**\*\*\*ADDENDUM TWO\*\*\***

**BID NUMBER B2017003  
PARKING STRUCTURE JOINT REPLACEMENT  
NOEL JUDICIAL COMPLEX  
222 Quaker Lane  
Warwick, Rhode Island**

**April 5, 2017**

1 TYP WALL SECTION  
 SKA1.0 SCALE: 1/4" = 1'-0"

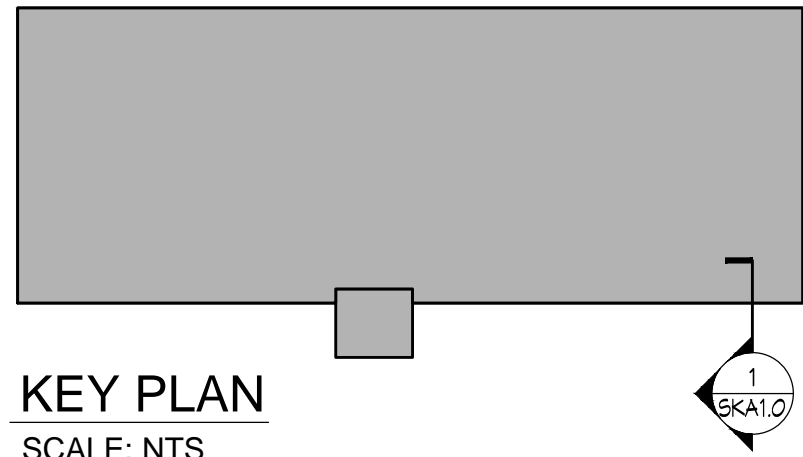
2. Question: What is the deck height for the partition walls?

**Response: See attached SKA1.0 for deck heights and typical perimeter wall height.**
